# SERVICE BULLETIN

**TITLE: FUEL - INSPECTION / REPLACEMENT OF FUEL VENT HOSE CLAMPS**

## SYNOPSIS OF CHANGE

Fuel Hose Access on Lower Right Wing  
Figure 2

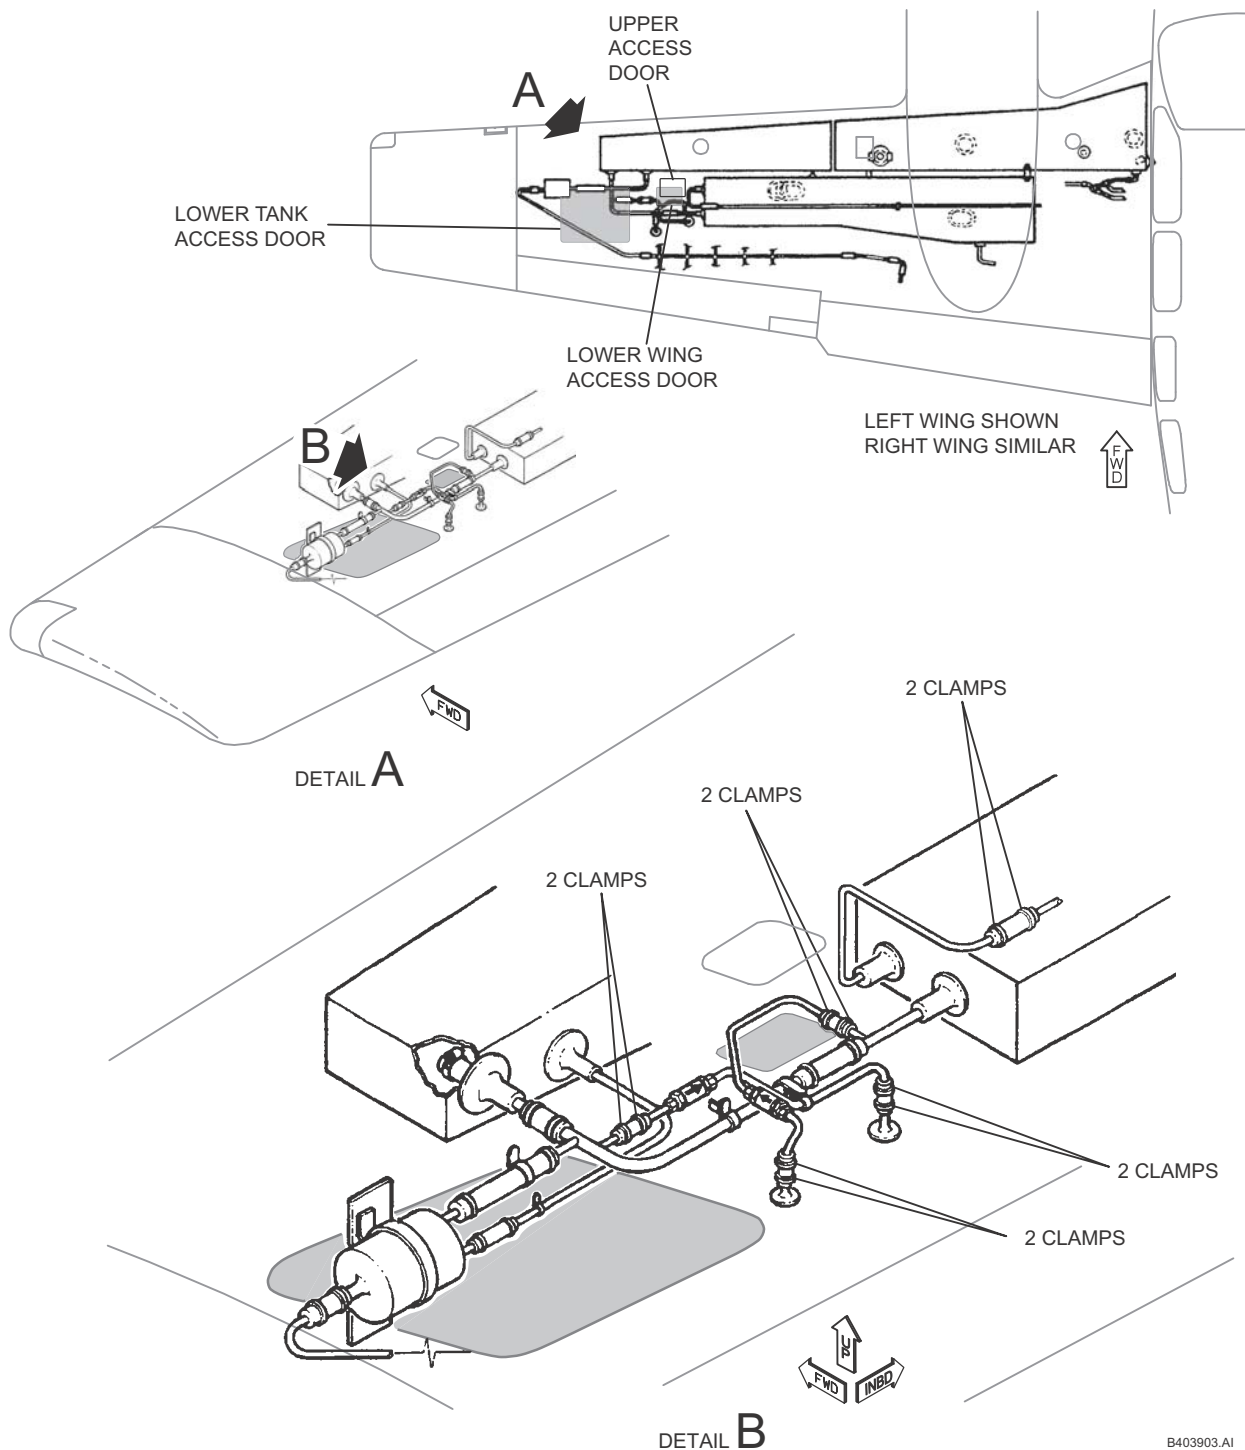
- (a) On left wing, remove three (3) access doors; two (2) on lower side and one (1) on upper side. Refer to Figure 1.
  - (b) On right wing, remove two (2) access doors on lower side. Refer to Figure 2.

**Fuel Hose Suspect Clamp Locations  
Optional Tip Tank Configuration (Serials TH-1931 thru TH-2119)  
Figure 4**

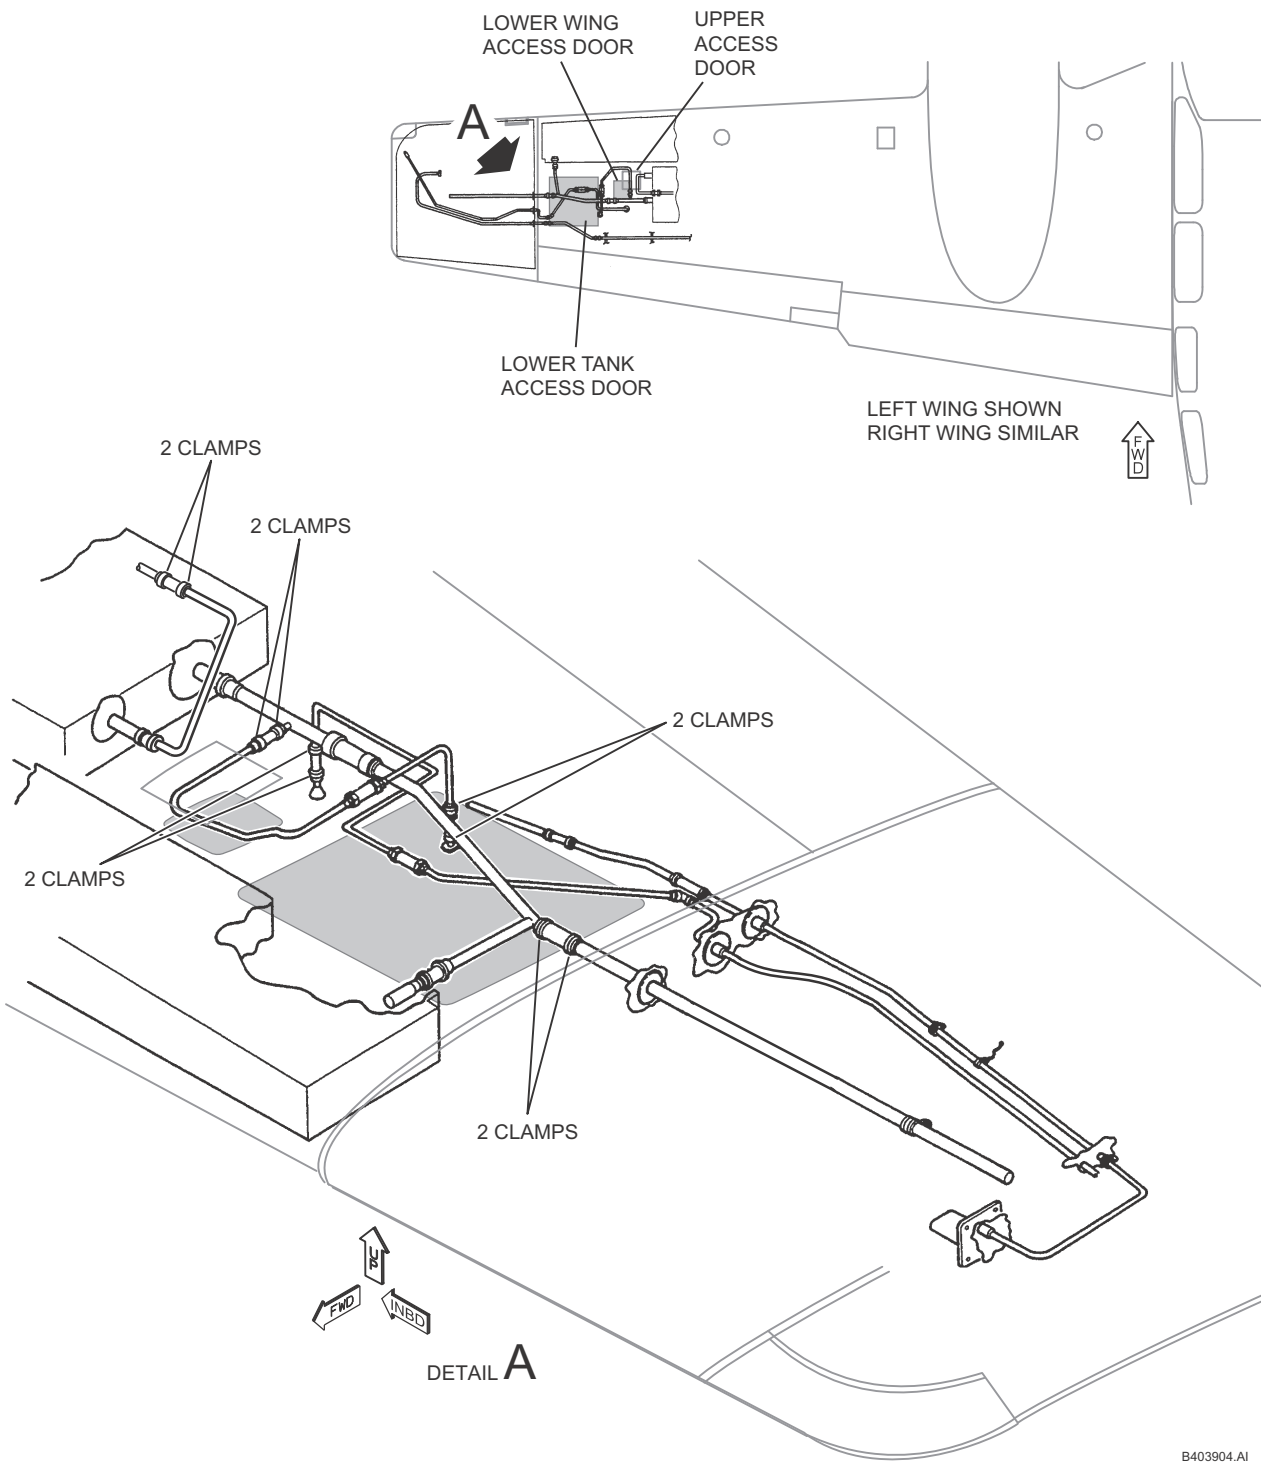
This Service Bulletin has been revised to clarify the quantity and location of the fuel hose clamps within the outboard section of each wing. Figure 3 was replaced and Figures 4 and 5 were added to illustrate the possible component configurations. If the original issue of this Service Bulletin has been complied with, then no further action is required. Relevant technical changes are marked with change bars in the outside margins.

- (c) With a mirror and a non-explosive flashlight, inspect areas for oversized/deformed clamps around the fuel hoses. Refer to Paragraph 2.C. for the quantity of clamps, depending on configuration. Refer to Figures 3, 4, and 5.

- (i) Inspect for gaps between the clamp and the hose. Clamps must be replaced if they do not close uniformly around the hose, are not concentric, or do not fit securely on the hose.

- (ii) If oversized/deformed clamp(s) are present, defuel the airplane before replacing clamps. Refer to MM, Chapter 28-00-00.
    - (iii) If oversized/deformed clamps are not present, proceed to Step (6) below.
- (3) Remove oversized/deformed clamp(s) and replace with new clamp(s), P/N 62606.
- (4) Refuel airplane to full capacity. Refer to MM, Chapter 12-10-00.
- (5) Visually inspect for fuel leaks around the hose clamps.
- (6) Install all wing access doors removed in Steps 2(a) and (b) above.
- (7) Reconnect the airplane battery, remove warning notices, and restore power.
- (8) Ensure all work areas are clean and clear of tools and miscellaneous items of equipment.
- (9) Return airplane to service.
